Design Change Notice (DCN)

Implemented Changes in KT-2509FM-01

Product: **Air-Curtain**

Model: **KAC-36TCRM / KAC-48TCRM**

1. EXTERNAL PARTS:

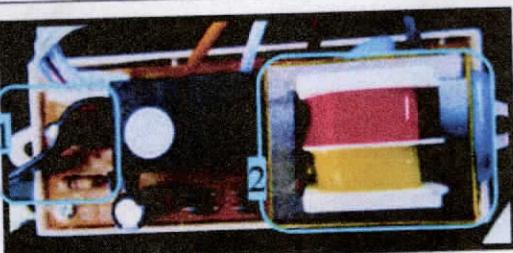
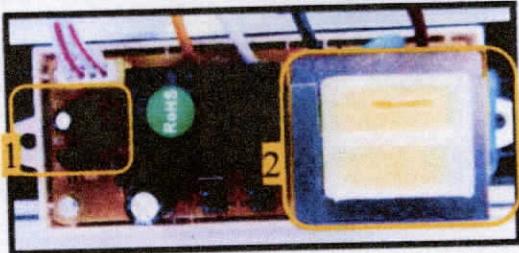
With AIR CURTAIN printed and with POP sticker on front panel

B. INTERNAL PARTS:

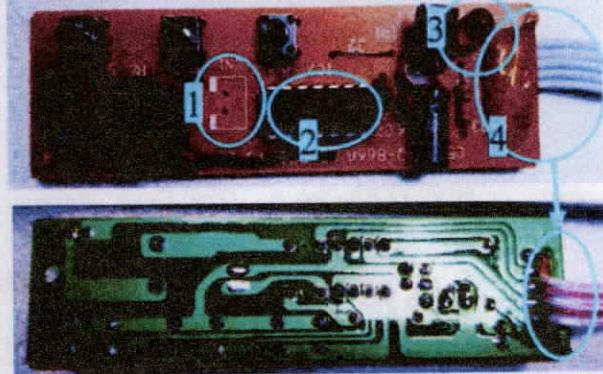
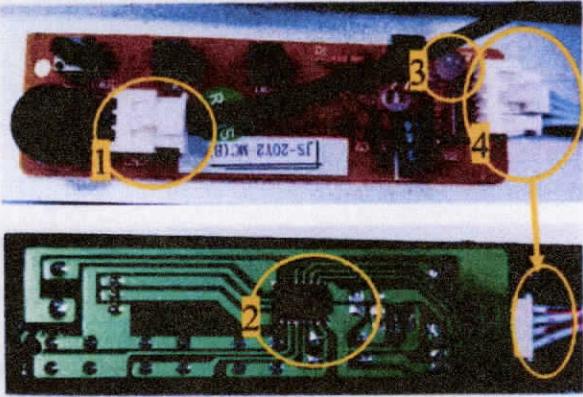
PREVIOUS MAIN PCB/ POWER SUPPLY	NEW MAIN PCB/ POWER SUPPLY
 <p>NY-866-FRZ 220V / 6.3A</p> <p>1. The DOOR sensor was connected 2. The transformer has no cover</p>	 <p>DY-2J (10) B220-W0(Y) B3 220-240V / 10A</p> <p>1. Removed the DOOR sensor and transfer to display board 2. The transformer has cover</p>
